UNITED STATES  
NUCLEAR REGULATORY COMMISSION  
WASHINGTON, D.C. 20555-0001

SAFETY EVALUATION BY THE OFFICE OF NUCLEAR REACTOR REGULATION  
RELATED TO AMENDMENT NO. 127 TO FACILITY OPERATING LICENSE NO. NPF-21  
WASHINGTON PUBLIC POWER SUPPLY SYSTEM  
NUCLEAR PROJECT NO. 2  
DOCKET NO. 50-397

FIGURE 1

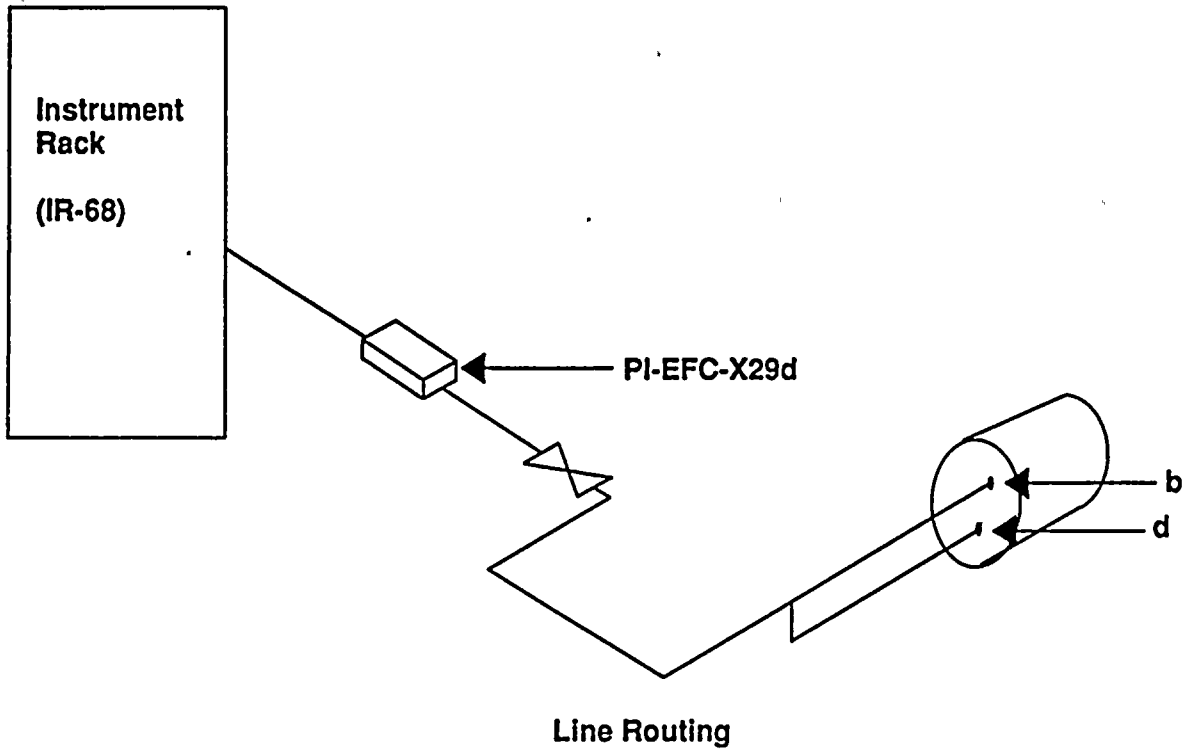
PI-EFC-X29d is an excess flow check valve on a drywell pressure sensing line to instrument rack IR-68. These type of instrument lines use a dual tube method to drain condensate from the lines. Figure 1 shows how bottom tube "d" acts as a trap and drains condensate from the instrument sensing line. This keeps condensate from building up and blocking the sensing line. TS Table 3.6.3-1 nomenclature uses instrument line penetration numbers to identify dual tube excess flow check valves. However, the TS table uses the drain line penetration number to identify valve PI-EFC-X29d. Renumbering valve PI-EFC-X29d to PI-EFC-X29b in TS Table 3.6.3-1 is an administrative-only change that will make TS valve numbering consistent. This valve renumbering will also make TS Table 3.6.3-1 consistent with existing plant design bases documents. These documents include the licensee's Master Equipment List, the process instrumentation drawing, and the TS surveillance procedure. We find this change to be acceptable.
